Subject	East West Rail Phase 1 – Arup responses to Paul Buckley’s correspondence dated 27th March 2015		
Date	15 April 2015	Job No/Ref	237838-00/H02-OB

Subject East West Rail Phase 1 – Arup responses to Paul Buckley’s correspondence dated 27th March 2015

Figure 1: Figure 16.10 from [3].

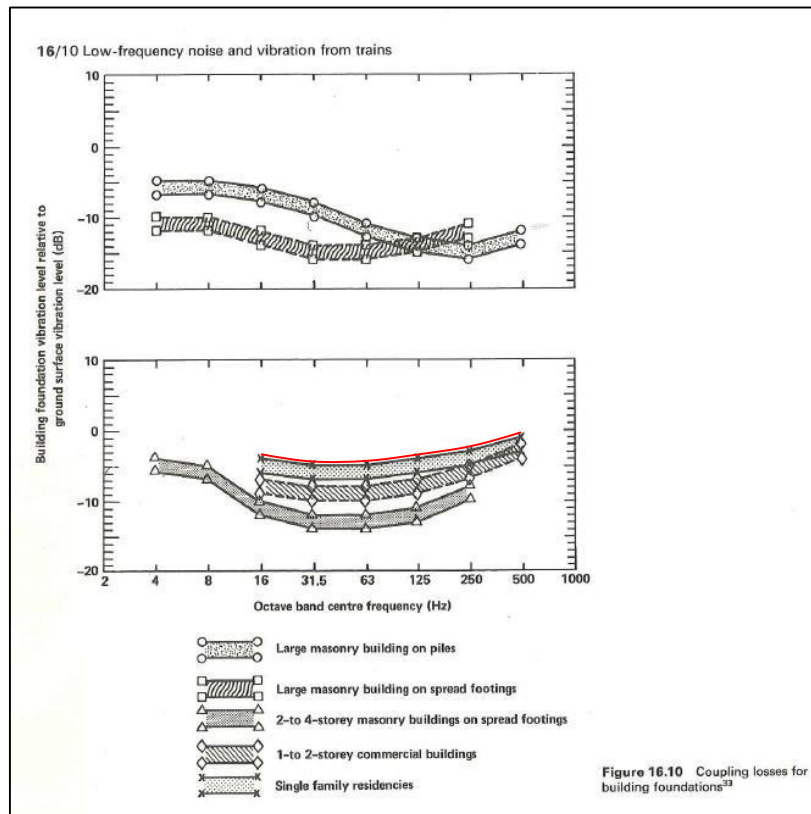
*“We are puzzled by the view expressed in the Arup Comments’ that ‘Alternative 2’, i.e. the second of the two approaches used by Atkins in the Technical Note, ‘provides the best available estimate of the amplification factor for each building’. There are two reasons we are puzzled. Firstly, it does not allow for the extra susceptibility of 2B Bladon Close. Secondly it seems to represent a mis-use of the data in the TNRB, in allowing neither for scatter in the responses of buildings of the same style of construction, nor for the known greater susceptibility of UK houses compared to the US buildings which form the data sets referred to in the TNRB – see Appendix 1 for further explanation of these misgivings. Available evidence suggests that use of the TNRB data in this way is incautious. It could easily lead to under-prediction of vibration amplification by at least 5dB (i.e. a factor of 1.8) – see Appendix 1”*

The Technical note by Atkins reproduces the data presented in the Transportation Noise Reference Book<sup>3</sup> (TNRB) for the range of coupling losses of various building foundations and the range of amplification of vibration due to floor resonances supported on columns. The figures are reproduced below.

Atkins used the coupling loss representing “single family residences” predict vibration levels at properties in Bladon Close. The measurement data used by the authors of the TNRB to derive the “single family residences” curve were measured largely in wood framed buildings in Canada. Also

the range of amplification factors due to floor resonances presented in the TNRB was derived in part from measurements made in the same study in Canada and therefore include measurements made in timber framed buildings. We can therefore provide assurance to the residents that the amplification factors presented in the Technical Note do take account of the susceptibility of timber framed buildings to vibration.

The approach used by Atkins to address coupling losses actually is cautious because the upper limit of the ‘single family residence’ classification from the TNRB has been used to derive the worst case amplification factor for 2B, 3 and 4 Bladon Close. This approach is therefore consistent with the ‘conservative’ approach recommended by D’Avillez et al.
